**GENUINE MOTOR PARTS AND
MOTOR ACCESSORIES BULLETIN**

P&A NO. 1021

**4-Point Docking Hardware Kit – Rushmore Models****Purpose**

This bulletin is to communicate changes to the design and the availability of a new 4-Point Docking Hardware Kit for '14-later Touring model (Part# 52300353). This kit supersedes the previous kit (Part #52300131).

See Figure 1.

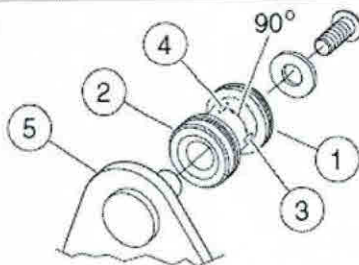
This new kit offers the ability to flip the docking point to increase or decrease the point spacing for optimal fit. In addition, the docking points are elliptical in shape allowing users to rotate the position ensuring the tightest fit. Installation and adjustment instructions are outlined in the included instruction sheet –J05999. (Figure 1. included as reference in this document)

- Install the docking points (1) to the docking plates (5) with the thicker flange (2) facing inward.
- The black plastic docking point insert is elliptical, with two notches 180 degrees apart indicating the largest diameter. With notches horizontal (3), docking point fit is loosest. With notches vertical (4), docking point fit is tightest.
